## QUALITY ASSURANCE -- NON-CONFORMANCE REPORT

**Report No:** NCR-000991

**Component:** East Anchorage Bearing Blocks - APBB1

**Reference Description:** Missed VT Indications Discovered by QA on Lift 14 East Anchorage Bearing Blocks

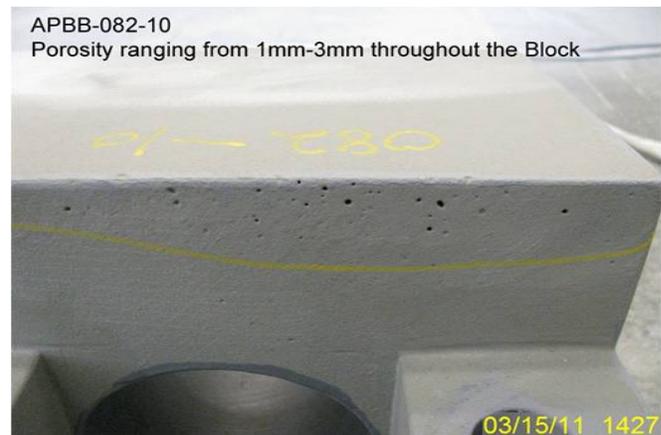
- The machined surfaces of seven of the APBBs, did not appear to comply with the contract documents.
- The surfaces exhibited excessive porosity.
- The discontinuities range from 1mm to 15mm in diameter.
- The material type is cast steel in accordance with ASTM A148 GR 550-345.
- The parts are identified as APBB1-082-10, 083-2, 057-1, 082-2, 082-1, 121-11 and 121-3.
- The APBBs have been visually tested and accepted by ZPMC QC. According to the contract documents, all castings shall be visually tested 100% on all surfaces.

ZPMC repaired the damaged area and re-inspected and accepted by QA. NDT reports were submitted showing the repair is acceptable. Internal NCR issued to the QC involved.
